UNITED STATES ARMY AVIATION BOARD
Fort Rucker, Alabama

14
ATBG-SEC-AVN-1561

6
SUBJECT: Service Test of Marking Light Kit, Landing and Drop Zone.

1 Incl
Lighting Diagram

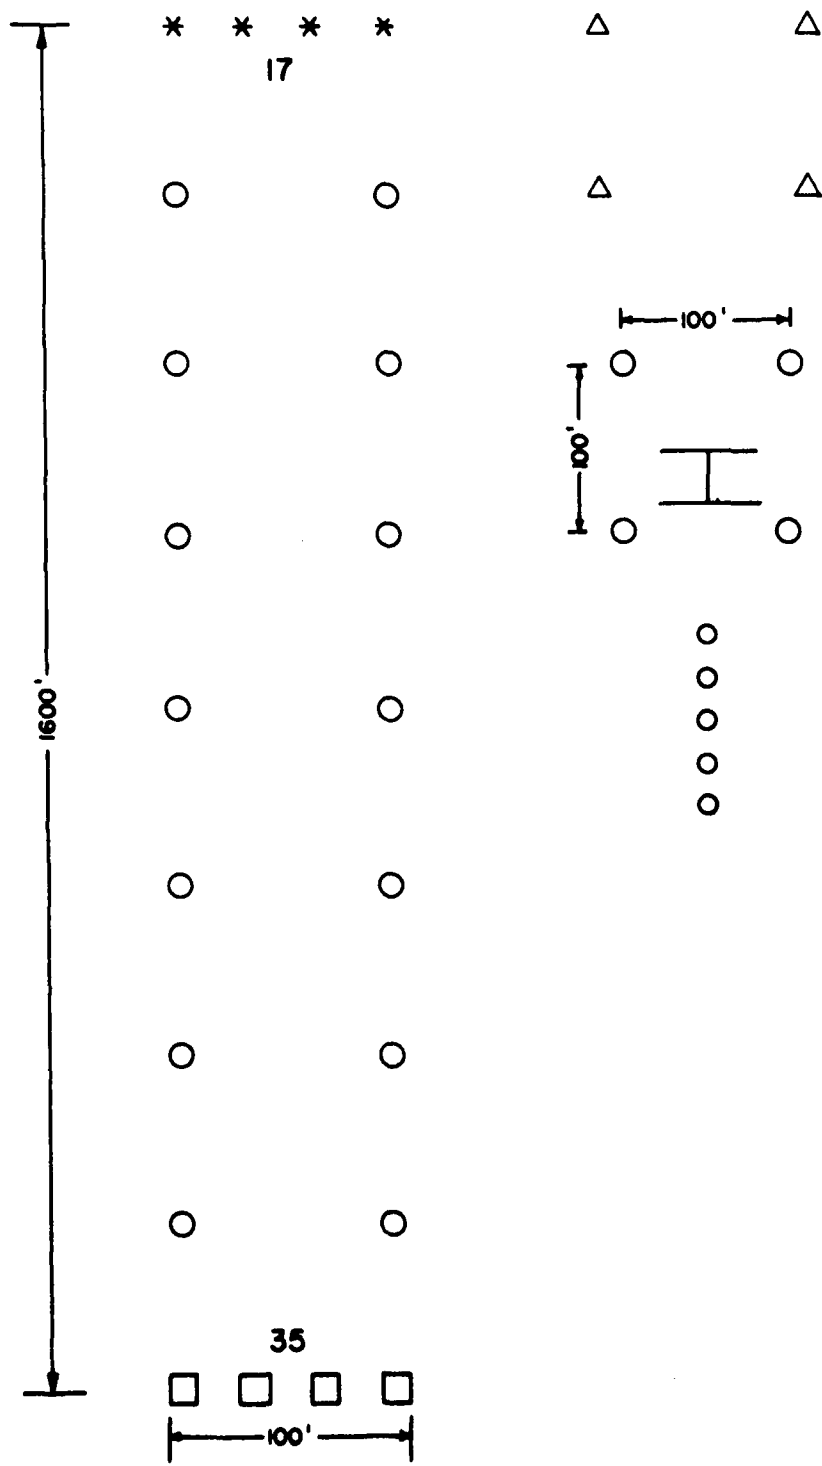
(a) Three men (one experienced in airfield lighting installations) using a 1/4-ton truck averaged one hour and thirty minutes to complete a landing strip layout (inclosure) including taxiways and threshold lights (34 lights) utilizing auxiliary power. For battery operation, the installation time averaged 30 minutes.
